**Re: E&A Team, Inc. Response to the SC Housing Qualifications Package Checklist**

Enclosed please find E&A Team, Inc.'s Qualification Package for South Carolina Housing.

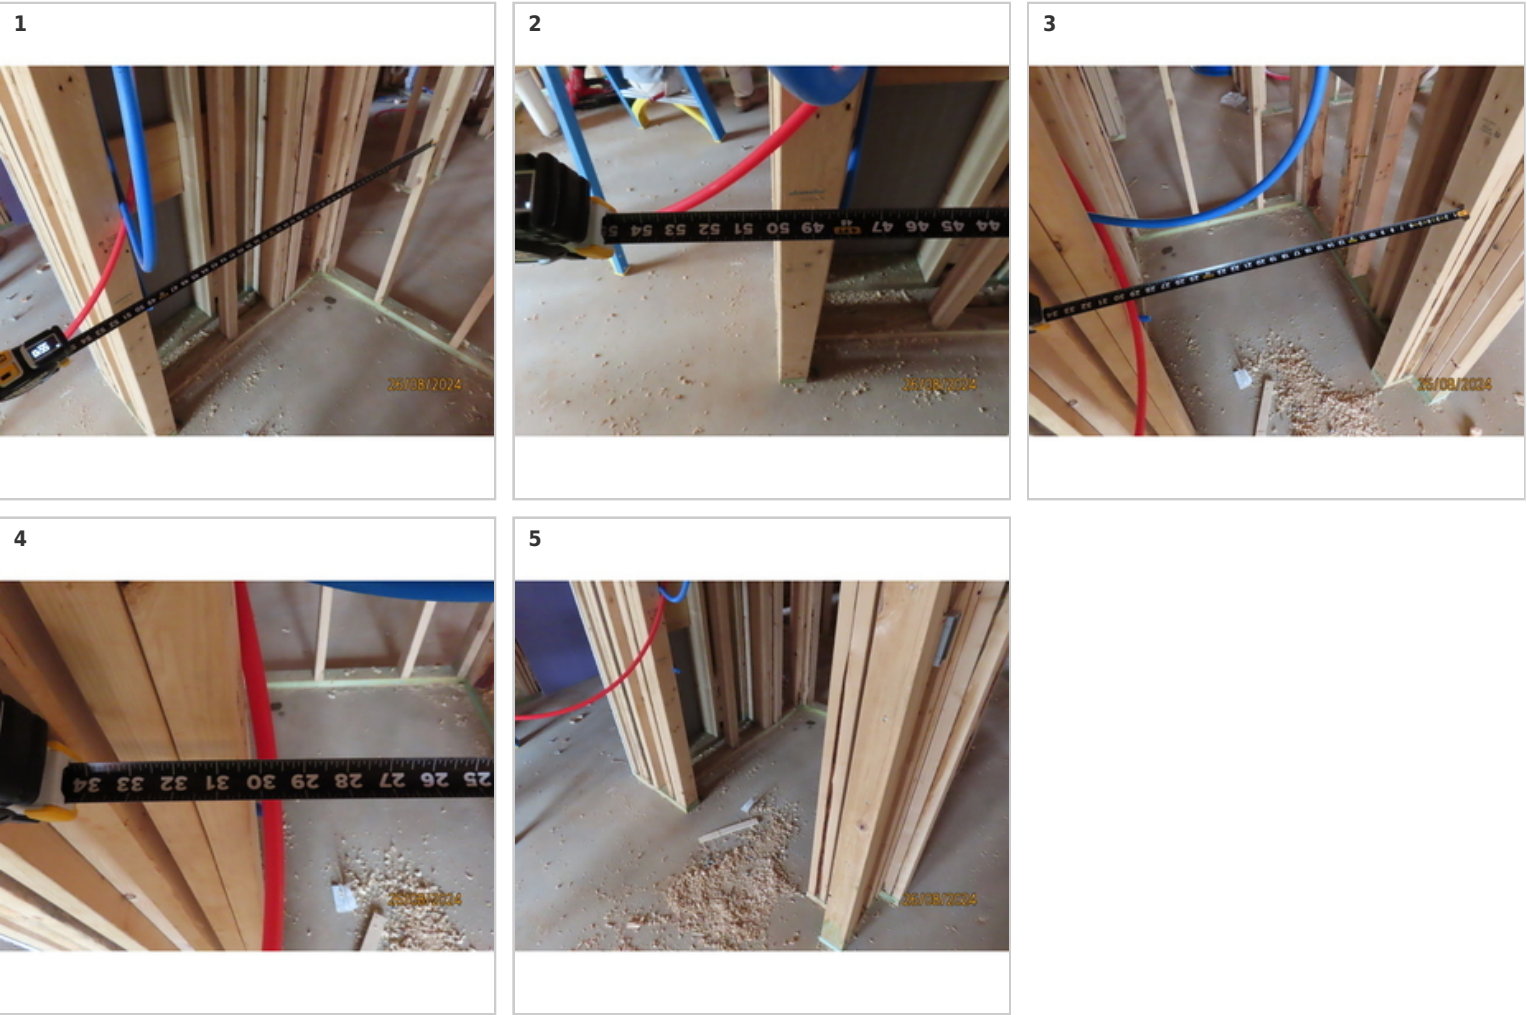
Priority 1 | Thomas White | 2024-0404 Visit  
Plan: 3br (unit C) - FH/Accessible | Location: FHA > 2102-3br > Bath #1

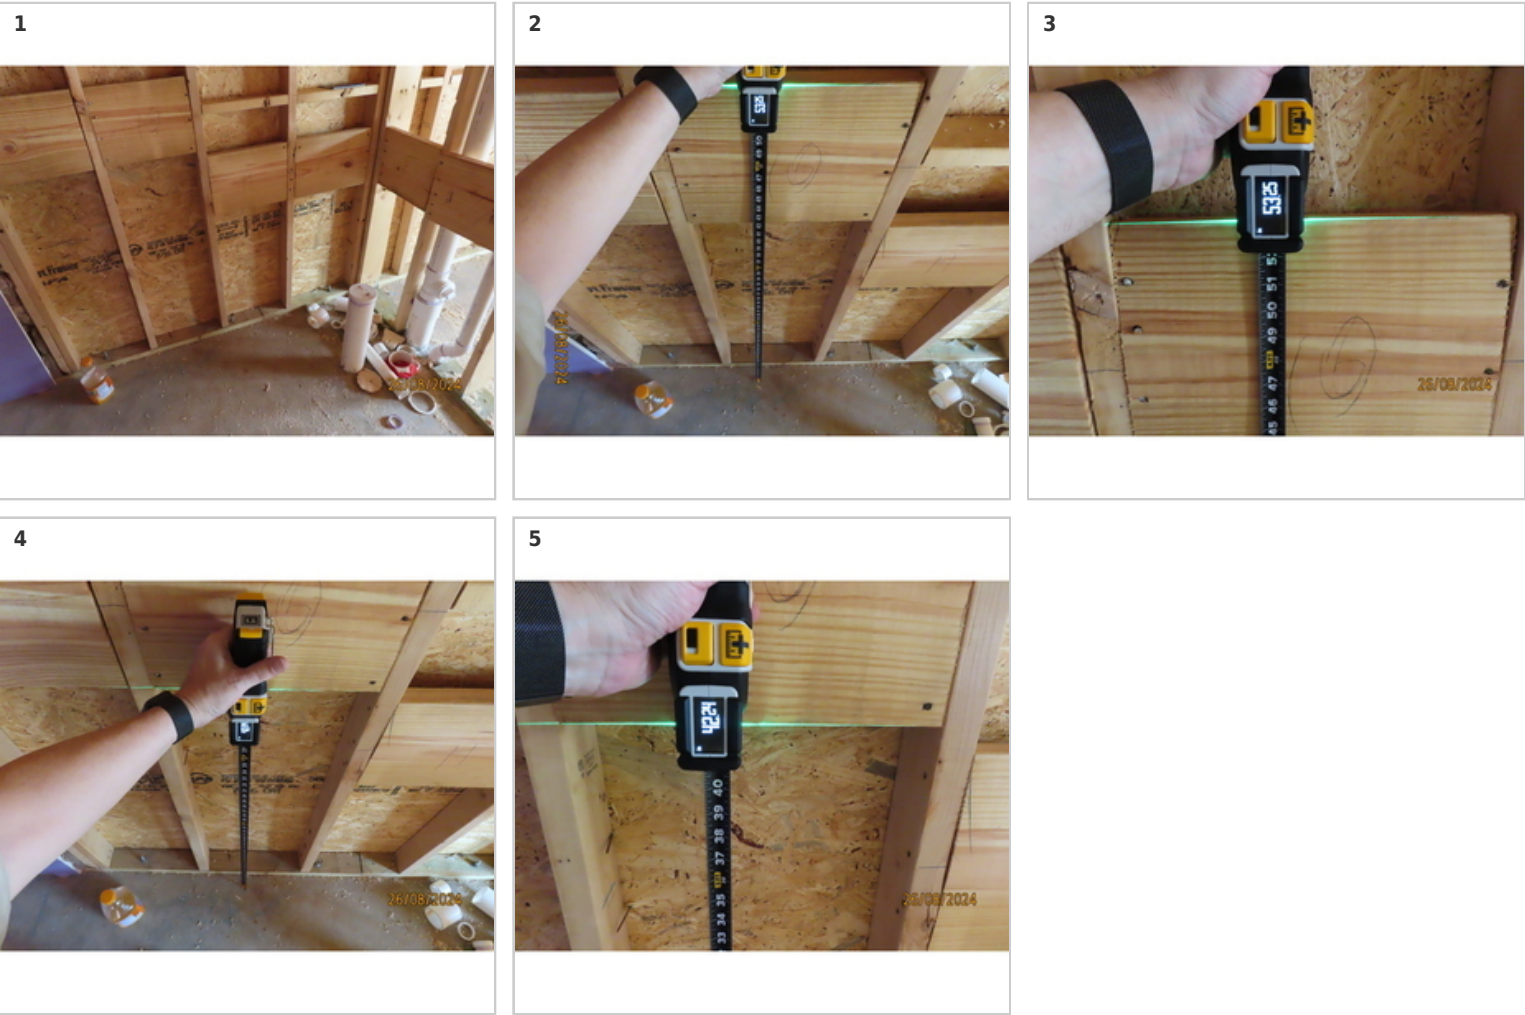
● **#37 - Side wall blocking for the toilet area is above the FHA range of 32-38 inches above the floor, please correct to the range show on sheet A1.5.**

Priority 2 | Thomas White | 2024-0404 Visit  
Plan: 2Br (unit B) - FH/Accessible | Location: FHA > 3101-2br > Bath #1

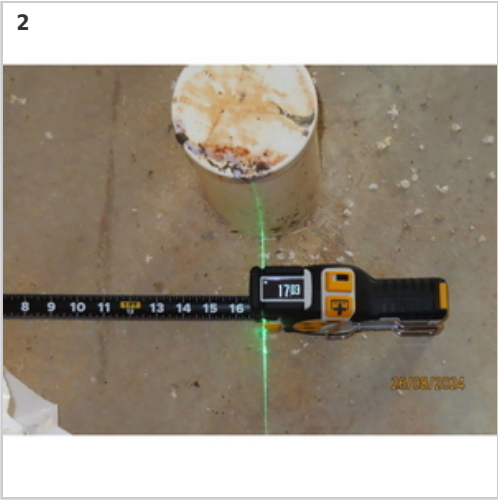
Priority 2 | Thomas White | 2024-0404 Visit  
Plan: 2Br (unit B) - FH/Accessible | Location: FHA > 4102-2br > Bath #1

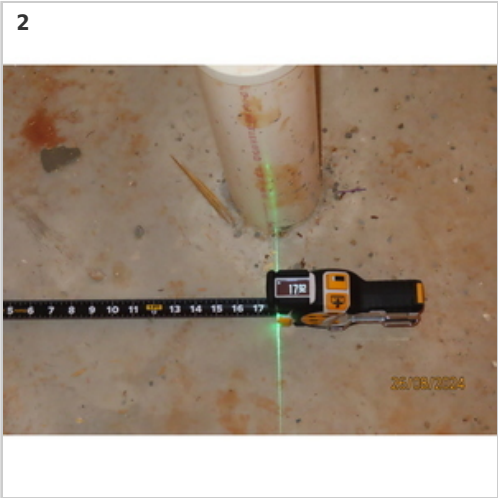
Priority 2 | Thomas White | 2024-0404 Visit  
Plan: 2Br (unit B) - FH/Accessible | Location: FHA > 5102-2br > Bath #1

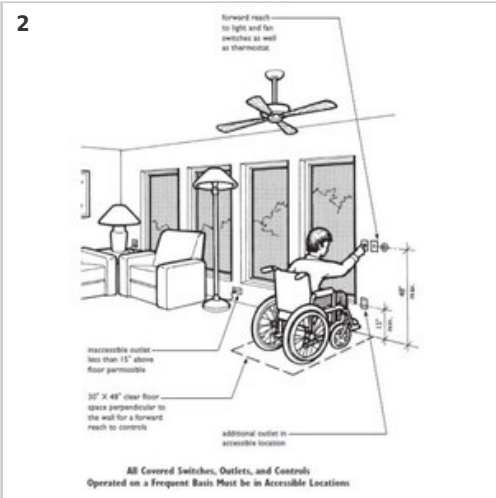
#45 - Thermostat above 48 inches  
Priority 2 | Scott Reynolds | 2023-12/11 1st Visit  
Plan: A2.1 - FIRST FLOOR BUILDING PLAN | Location: 101  
Created 12-11-2023

Scott Reynolds	Photo 1	11 Dec 07:20 AM
Alva George	Fair Housing Act Design Manual - Requirement 5 -Light Switches, Electrical Outlets, Thermostats, and Other Environmental Controls in Accessible Locations	13 Dec 07:37 AM
Alva George	Photo 2	13 Dec 07:38 AM
Alva George	ANSI A117.1[2003]1004.9 Operable Parts. Lighting controls electrical switches and receptacle outlets, environmental controls, and user controls for security or intercom systems shall comply with Sections 309.2 and 309.3.	13 Dec 07:42 AM
Alva George	Locate controls at 48 inches or below.	13 Dec 07:42 AM

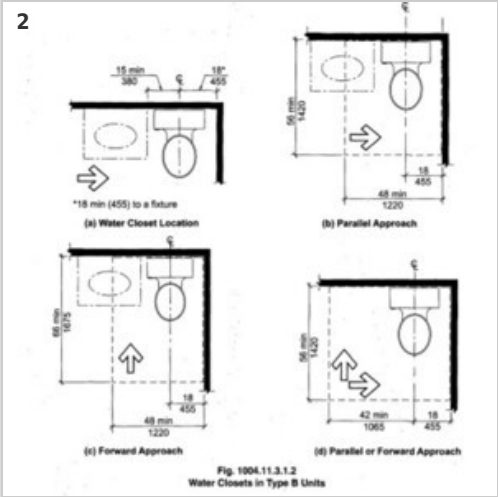
#16 - Toilet not 18 inches-Provide clear floor space at water closet.  
Priority 2 | Scott Reynolds | 2023-12/11 1st Visit  
Plan: A2.1 - FIRST FLOOR BUILDING PLAN | Location: 102  
Created 12-11-2023

Scott Reynolds	Photo 1	11 Dec 06:33 AM
Alva George	Photo 2	12 Dec 08:40 AM
Alva George	Fair Housing Act Design Manual - Requirement 7 Usable Kitchens and Bathrooms Part A:Usable Kitchens Part B: Usable Bathrooms	12 Dec 08:43 AM

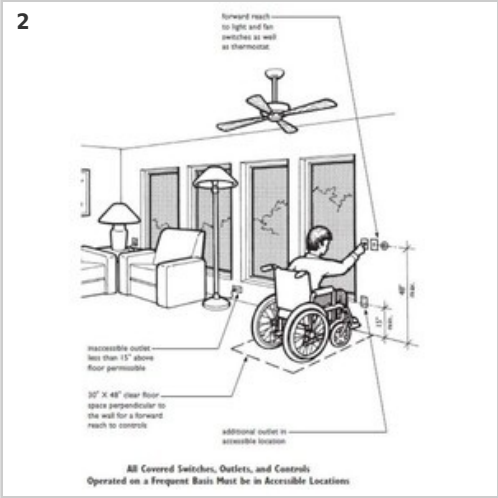
● #46 - Thermostat above 48 inches  
Priority 2 | Scott Reynolds | 2023-12/11 1st Visit  
Plan: A2.1 - FIRST FLOOR BUILDING PLAN | Location: 102  
Created 12-11-2023

Scott Reynolds	Photo 1	11 Dec 07:21 AM
Alva George	Fair Housing Act Design Manual - Requirement 5 -Light Switches, Electrical Outlets, Thermostats, and Other Environmental Controls in Accessible Locations	13 Dec 08:14 AM
Alva George	Photo 2	13 Dec 08:14 AM
Alva George	ANSI A117.1[2003]1004.9 Operable Parts. Lighting controls electrical switches and receptacle outlets, environmental controls, and user controls for security or intercom systems shall comply with Sections 309.2 and 309.3. Locate controls at 48 inches or below.	13 Dec 08:14 AM

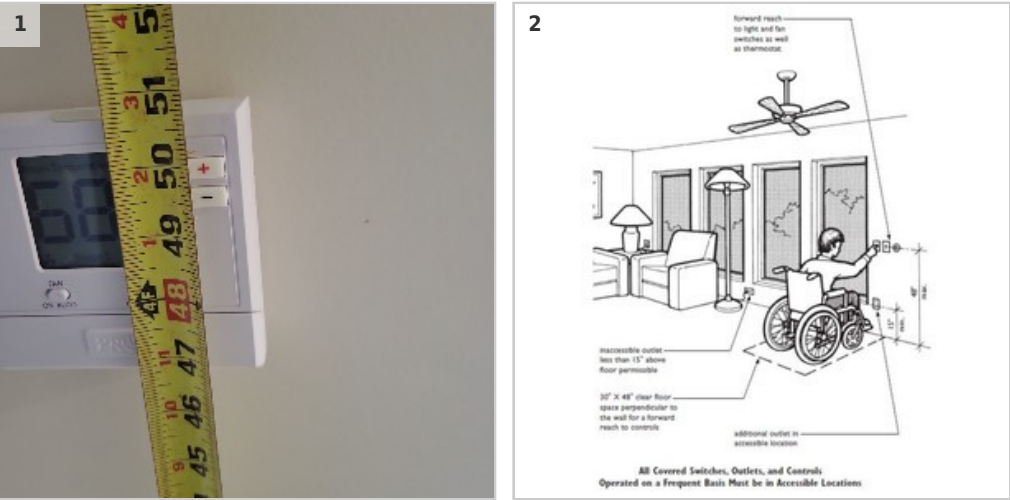
● **#47 - Thermostat above 48 inches**  
Priority 2 | Scott Reynolds | 2023-12/11 1st Visit  
Plan: A2.1 - FIRST FLOOR BUILDING PLAN | Location: 103  
Created 12-11-2023

Task messages (time in PDT)		
Scott Reynolds	Photo 1	11 Dec 07:22 AM
Alva George	Fair Housing Act Design Manual - Requirement 5 -Light Switches, Electrical Outlets, Thermostats, and Other Environmental Controls in Accessible Locations	13 Dec 08:16 AM
Alva George	Photo 2	13 Dec 08:16 AM
Alva George	ANSI A117.1[2003]1004.9 Operable Parts. Lighting controls electrical switches and receptacle outlets, environmental controls, and user controls for security or intercom systems shall comply with Sections 309.2 and 309.3. Locate controls at 48 inches or below.	13 Dec 08:19 AM

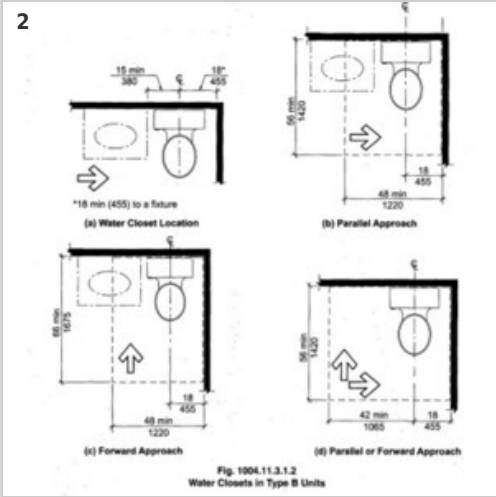
● **#21 - Toilet not 18 inches-Provide clear floor space at water closet.**  
Priority 2 | Scott Reynolds | 2023-12/11 1st Visit  
Plan: A2.1 - FIRST FLOOR BUILDING PLAN | Location: 104  
Created 12-11-2023

Task messages (time in PDT)		
Scott Reynolds	Photo 1	11 Dec 06:39 AM
Alva George	Photo 2	12 Dec 10:17 AM
Alva George	Fair Housing Act Design Manual - Requirement 7 Usable Kitchens and Bathrooms Part A:Usable Kitchens Part B: Usable Bathrooms	12 Dec 10:17 AM

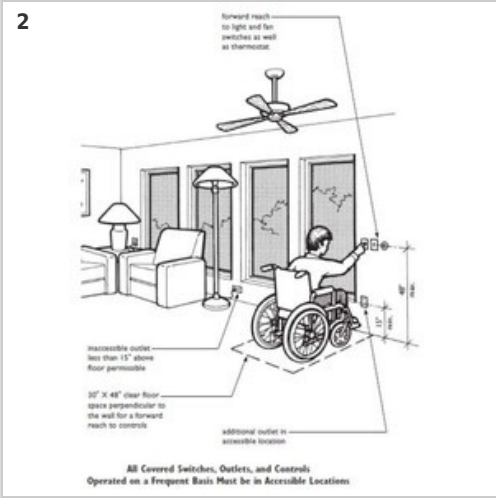
● **#48 - Thermostat above 48 inches**  
Priority 2 | Scott Reynolds | 2023-12/11 1st Visit  
Plan: A2.1 - FIRST FLOOR BUILDING PLAN | Location: 104  
Created 12-11-2023

Scott Reynolds	Photo 1	11 Dec 07:23 AM
Alva George	Fair Housing Act Design Manual - Requirement 5 -Light Switches, Electrical Outlets, Thermostats, and Other Environmental Controls in Accessible Locations	13 Dec 08:20 AM
Alva George	Photo 2	13 Dec 08:21 AM
Alva George	ANSI A117.1[2003]1004.9 Operable Parts. Lighting controls electrical switches and receptacle outlets, environmental controls, and user controls for security or intercom systems shall comply with Sections 309.2 and 309.3. Locate controls at 48 inches or below.	13 Dec 08:21 AM

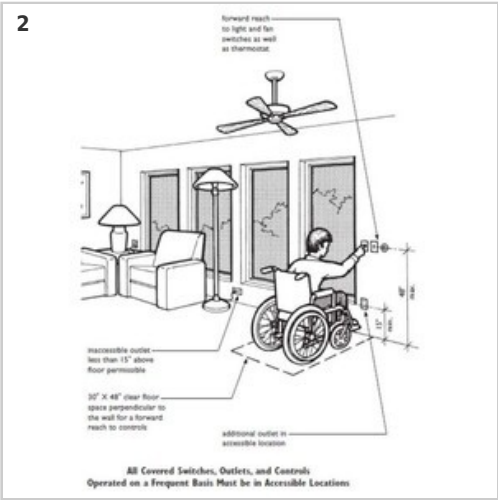
● **#49 - Thermostat above 48 inches**  
Priority 2 | Scott Reynolds | 2023-12/11 1st Visit  
Plan: A2.1 - FIRST FLOOR BUILDING PLAN | Location: 105  
Created 12-11-2023

Task messages (time in PDT)		
Scott Reynolds	Photo 1	11 Dec 07:24 AM
Alva George	Fair Housing Act Design Manual - Requirement 5 -Light Switches, Electrical Outlets, Thermostats, and Other Environmental Controls in Accessible Locations	13 Dec 08:22 AM
Alva George	Photo 2	13 Dec 08:22 AM
Alva George	ANSI A117.1[2003]1004.9 Operable Parts. Lighting controls electrical switches and receptacle outlets, environmental controls, and user controls for security or intercom systems shall comply with Sections 309.2 and 309.3. Locate controls at 48 inches or below.	13 Dec 08:23 AM

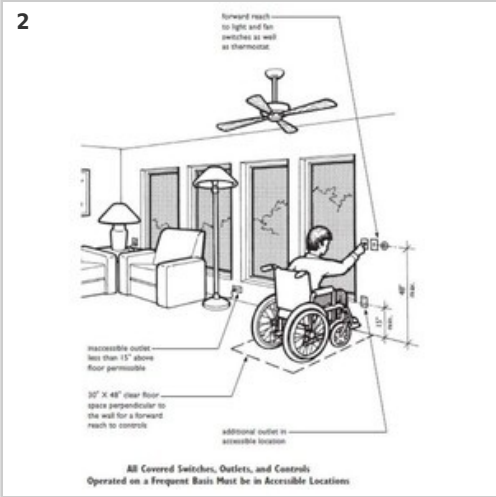
● **#52 - Thermostat above 48 inches**  
Priority 2 | Scott Reynolds | 2023-12/11 1st Visit  
Plan: A2.1 - FIRST FLOOR BUILDING PLAN | Location: 109  
Created 12-11-2023

Task messages (time in PDT)		
Scott Reynolds	Photo 1	11 Dec 07:34 AM
Alva George	ANSI A117.1[2003]1004.9 Operable Parts. Lighting controls electrical switches and receptacle outlets, environmental controls, and user controls for security or intercom systems shall comply with Sections 309.2 and 309.3. Locate controls at 48 inches or below.	13 Dec 09:40 AM
Alva George	Photo 2	13 Dec 09:40 AM

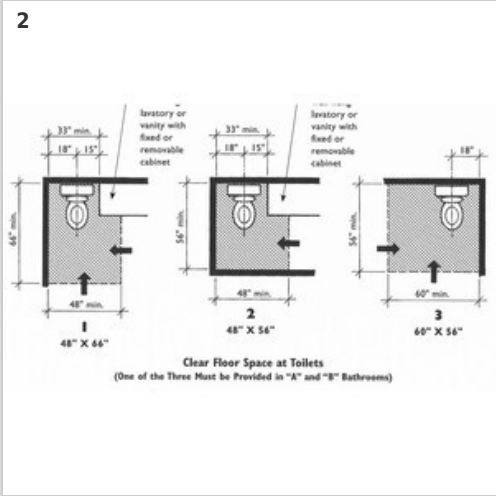
● #55 - Toilet not 18 inches-Provide clear floor space at water closet.

Priority 2 | Scott Reynolds | 2023-12/11 1st Visit  
Plan: A2.1 - FIRST FLOOR BUILDING PLAN | Location: 110  
Created 12-11-2023

Scott Reynolds	Photo 1	11 Dec 07:37 AM
Alva George	Fair Housing Act Design Manual - Requirement 7 Usable Kitchens and Bathrooms Part A:Usable Kitchens Part B: Usable Bathrooms	13 Dec 10:00 AM
Alva George	Photo 2	13 Dec 10:00 AM

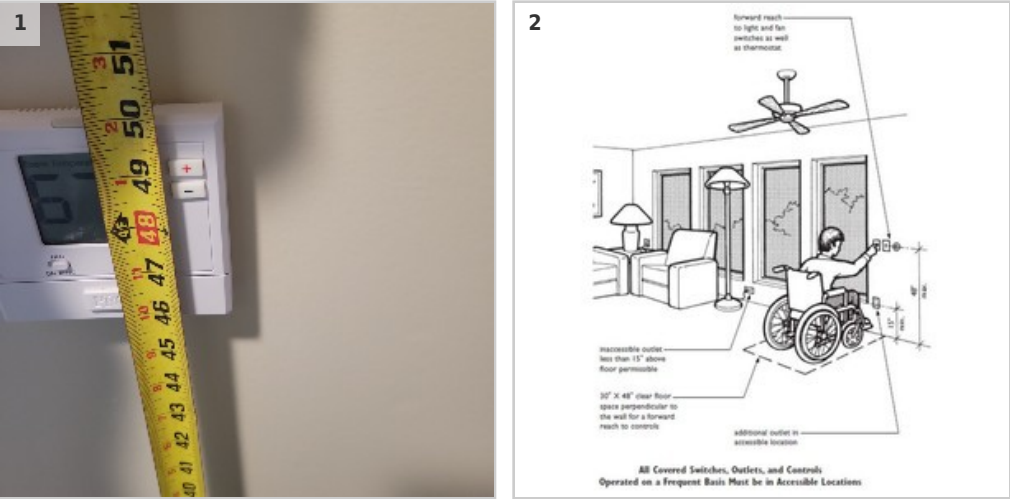
● **#76 - Thermostat above 48 inches**  
Priority 2 | Scott Reynolds | 2023-12/11 1st Visit  
Plan: A2.2 - SECOND FLOOR BUILDING PLAN | Location: 202  
Created 12-11-2023

Scott Reynolds	Photo 1	11 Dec 08:12 AM
Alva George	Fair Housing Act Design Manual - Requirement 5 -Light Switches, Electrical Outlets, Thermostats, and Other Environmental Controls in Accessible Locations ANSI A117.1[2003]1004.9 Operable Parts. Lighting controls electrical switches and receptacle outlets, environmental controls, and user controls for security or intercom systems shall comply with Sections 309.2 and 309.3. Locate controls at 48 inches or below.	13 Dec 01:34 PM
Alva George	Photo 2	13 Dec 01:34 PM

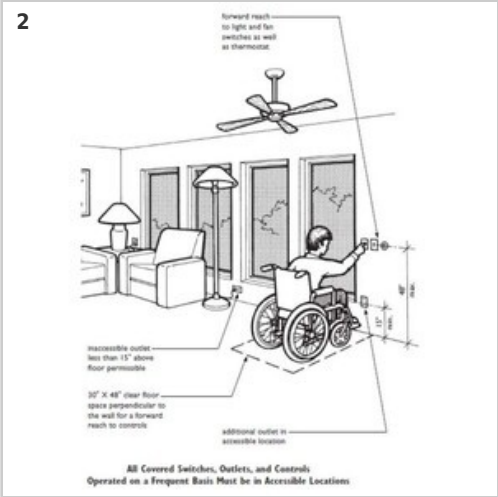
● **#80 - Thermostat above 48 inches**  
Priority 2 | Scott Reynolds | 2023-12/11 1st Visit  
Plan: A2.2 - SECOND FLOOR BUILDING PLAN | Location: 203  
Created 12-11-2023

Scott Reynolds	Photo 1	11 Dec 08:16 AM
Alva George	Fair Housing Act Design Manual - Requirement 5 -Light Switches, Electrical Outlets, Thermostats, and Other Environmental Controls in Accessible Locations ANSI A117.1[2003]1004.9 Operable Parts. Lighting controls electrical switches and receptacle outlets, environmental controls, and user controls for security or intercom systems shall comply with Sections 309.2 and 309.3. Locate controls at 48 inches or below.	14 Dec 06:34 AM
Alva George	Photo 2	14 Dec 06:34 AM

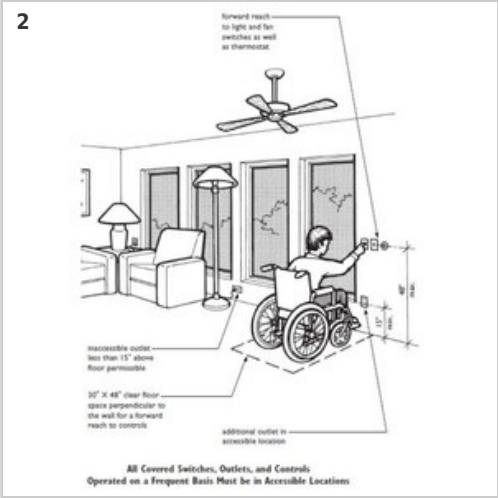
● **#83 - Thermostat above 48 inches**  
Priority 2 | Scott Reynolds | 2023-12/11 1st Visit  
Plan: A2.2 - SECOND FLOOR BUILDING PLAN | Location: 204  
Created 12-11-2023

Scott Reynolds	Photo 1	11 Dec 08:20 AM
Alva George	Fair Housing Act Design Manual - Requirement 5 -Light Switches, Electrical Outlets, Thermostats, and Other Environmental Controls in Accessible Locations ANSI A117.1[2003]1004.9 Operable Parts. Lighting controls electrical switches and receptacle outlets, environmental controls, and user controls for security or intercom systems shall comply with Sections 309.2 and 309.3.	14 Dec 06:39 AM
Alva George	Photo 2	14 Dec 06:40 AM
Alva George	Locate controls at 48 inches or below.	14 Dec 06:40 AM

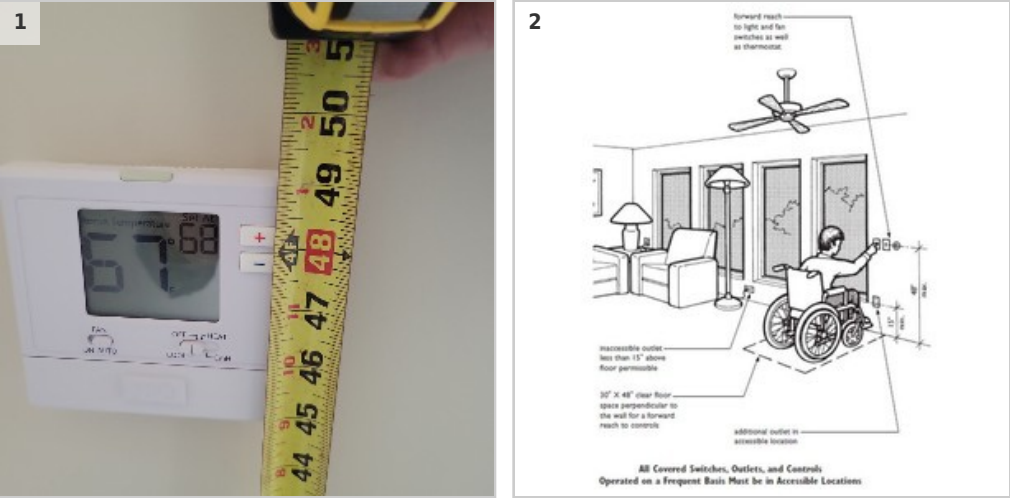
● **#90 - Thermostat above 48 inches**  
Priority 2 | Scott Reynolds | 2023-12/11 1st Visit  
Plan: A2.2 - SECOND FLOOR BUILDING PLAN | Location: 206  
Created 12-11-2023

Task messages (time in PDT)		
Scott Reynolds	Photo 1	11 Dec 08:27 AM
Alva George	Fair Housing Act Design Manual - Requirement 5 -Light Switches, Electrical Outlets, Thermostats, and Other Environmental Controls in Accessible Locations ANSI A117.1[2003]1004.9 Operable Parts. Lighting controls electrical switches and receptacle outlets, environmental controls, and user controls for security or intercom systems shall comply with Sections 309.2 and 309.3.	14 Dec 10:38 AM
Alva George	Photo 2	14 Dec 10:38 AM
Alva George	Locate controls at 48 inches or below.	14 Dec 10:49 AM

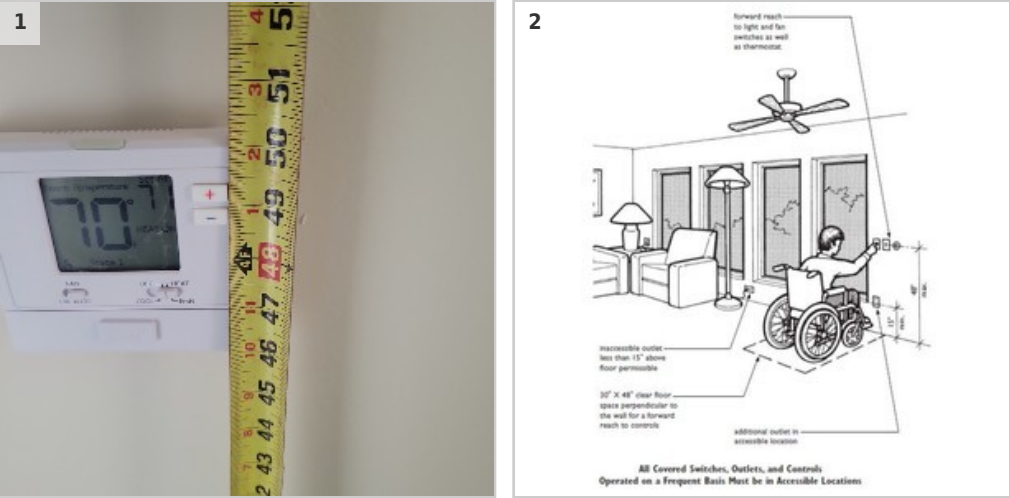
● **#93 - Thermostat above 48 inches**  
Priority 2 | Scott Reynolds | 2023-12/11 1st Visit  
Plan: A2.2 - SECOND FLOOR BUILDING PLAN | Location: 207  
Created 12-11-2023

Task messages (time in PDT)		
Scott Reynolds	Photo 1	11 Dec 08:30 AM
Alva George	Fair Housing Act Design Manual - Requirement 5 -Light Switches, Electrical Outlets, Thermostats, and Other Environmental Controls in Accessible Locations ANSI A117.1[2003]1004.9 Operable Parts. Lighting controls electrical switches and receptacle outlets, environmental controls, and user controls for security or intercom systems shall comply with Sections 309.2 and 309.3.	14 Dec 10:39 AM
Alva George	Photo 2	14 Dec 10:49 AM
